17/00434/PPP Land 160 Metres South Of Broadgate House, Campsie Road, Strathblane

Strathblane Community Council provides its response to Gladman's application for Planning Permission in Principle for a substantial residential development on Campsie Road, Strathblane, and the moving of the existing green belt boundary and currently designated cemetery to a location further east.

Figure 16 Detail from applicant's Drainage Report, Appendix 1 (red arrow indicates "tree Island"; blue arrows indicate drainage from garden grounds not captured by SUDS; green arrows indicate flow unaccounted for, arriving from slopes to the south)

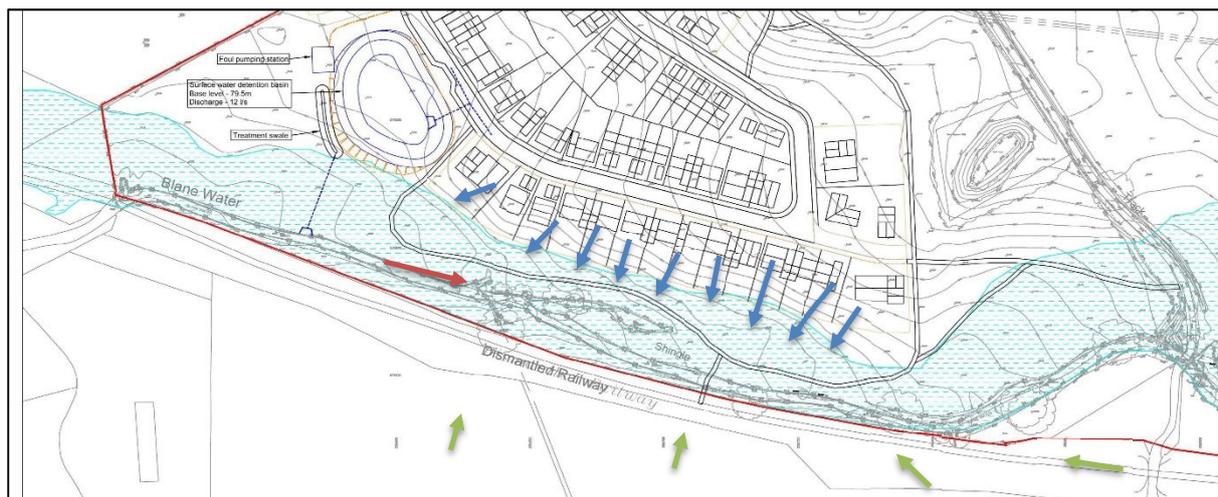
Figure 16 is a map detail from the applicant's Drainage Report above. Notice in Figure 7 and Figure 9 the long, thin "island" with mature trees. This allows us to relate these photographs to the indicative masterplan, and the drainage map of the site.

As can be seen from the photographs, the footpaths in the indicative masterplan will flood routinely, not only every 200 years. The models used do not seem to take into account extensive flows and flooding observed along and around the Railway Path, whose origin is unknown. These may be arriving down the slopes from the south and east of the site, outside the selected model. Likewise, the models used in the FRA do not seem to predict the standing water in the northern part of the site, visible in the recent photo Figure 17, below.

Even a casual view of this drainage map calls into question whether the SUDS proposed can realistically achieve the goal of no increased run-off, compared with the greenfield site. Referring to the blue arrows, which follow the slope indicated by the contours, there is no obvious way for drainage from these 14-15 gardens to reach the surface water detention basin. Section 6.4 of the Drainage Report confesses that the design of the drainage system "is not part of the commission" and is a detail to be "discussed and agreed with Stirling Council". The community will have no confidence in any "maintenance regime", particularly if the risk of flash flooding is primarily to properties and public spaces downstream, and not to this proposed housing development itself.

Figure 21 Bus stop locations

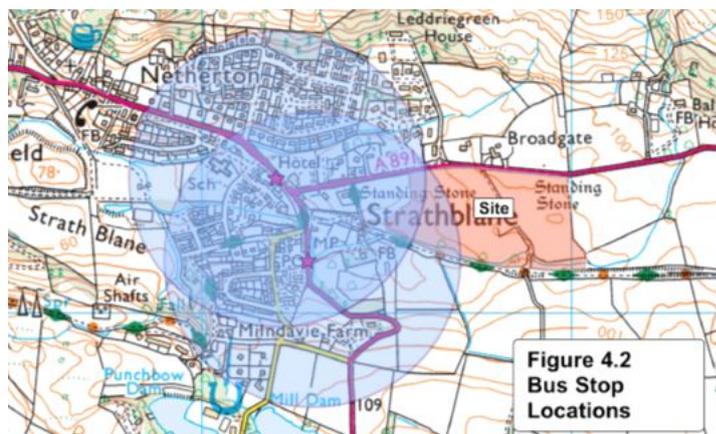
According to the illustrative masterplan, walking distances within the site could exceed 200 m. The report suggests at one point that a shortcut would be available through the John Muir Way, but that is clearly a mistake. There is no route via the John Muir Way to the southern bus stop shown, or to other services, except by returning to the A891, opposite the church. Such a walking route is therefore longer, not shorter, than a direct exit through the site.

Figure 21, taken from the applicant's report, shows how the existing settlement, including the site identified for development in the LDP, lies within the 400 m circles, while the new site lies plainly without. Therefore, the use of bus transport (even if there were adequate bus transport for most users) would not be sufficiently encouraged.

Figure 22 Extract from Transport Assessment, Appendix C

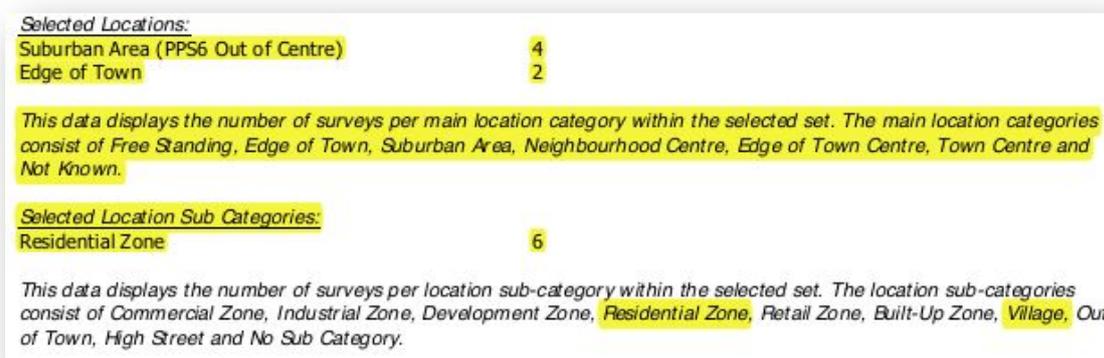
The vehicle "trip rate" estimates that are used in the Transport Assessment are plainly too low. They assume as an "inflated worst case" scenario that each house will generate 0.5 vehicle trips in the morning rush-hour and 0.5 vehicle trips in the evening. Anyone considering the pattern of commuting to/from work and school in Glasgow or elsewhere knows that this figure is absurdly low. Most of the houses will be family houses, and most of them will generate at least one car trip per rush-hour. Trying to understand where the figures in the Transport Assessment have come from, we have studied the supporting materials. In the Appendix C of the Transport Assessment (See extract in Figure 22 below), it is revealed that the Trip rate predictions are based on "suburban" and "edge of town" precedents. Apparently, the statistical database recognises "free-standing" and "village" scenarios, but for whatever reason these were not used.

In short, we would suggest that the additional traffic flows generated by this site will likely be double or more, those assumed in the applicant's Transport Assessment.
